66319B-09

S E R V I C E N O T E

**66319B - Mobile Communication DC Source, Dual-Output
15V/3A,12V/1.5A. GPIB**

**Power-On Self test Errors, Auto reboot, Blank display. No output Communication errors.
No communication when using the GPIB Interface.**

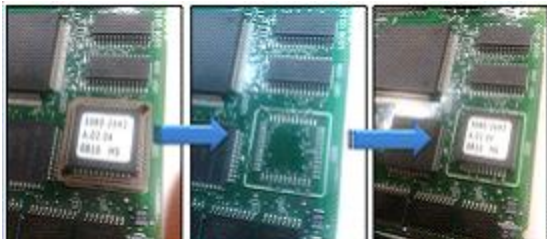
When the EEPROM is installed in the PLCC SOCKET (**Circuit Reference U205**) on the Interface board if there is not a gas tight connection between the EEPROM pins and the socket pins an intermittent connection will occur.

The pin connections may not be reliable. Over time the pins may become intermittent which will cause the instrument to exhibit the defects described below.

It has been determined when removing the socket and soldering the EEPROM (circuit reference U205) directly on the interface assembly “A2” would be very difficult (See Picture below), even having the correct tools, removal of the socket and replacement of the EEPROM is very difficult and may cause additional quality and reliability issues.

1. The problem can be solved by replacing the GPIB Interface assembly. See above for the tested interface P/N that is required to repair the instrument. The correct tested assembly for the specific model must be used when repairing a defective instrument.
2. This problem can also be solved by removing the socket (circuit reference U205) on the “A2” interface assembly and soldering the **Original** EEPROM directly to the Printed Circuit assembly Initialization and calibration problems.
